Bulletin

Volvo XC90 Model year: 2003 - 2004 Up to VIN: 079857

Cold air stream in the footwell

Template for ventilation louvre (scale 1:1)

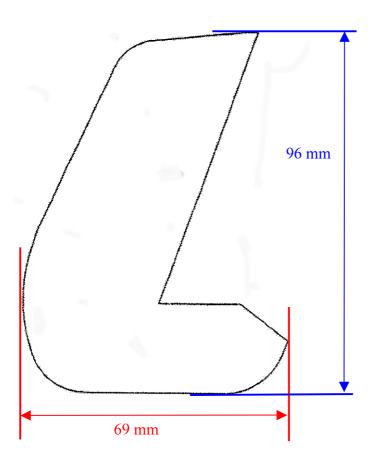
With the above-mentioned vehicles there can be a very cold air stream in the driver footwell when the air-conditioning is switched on. This occurs particularly when high outdoor temperatures are prevailing. In this case, a thin, L-shaped piece of foam should be glued to the back of the footwell air vents.

- Remove the ventilation louvre in the driver's footwell
- Cut out the template (scale 1:1) and transfer the dimensions onto the foam
- Cut out the foam and use double-sided adhesive tape to stick it to the back of the ventilation louvre in such a way that the air flow opening is reduced by approx. 1/3
- Mount the ventilation louvre again
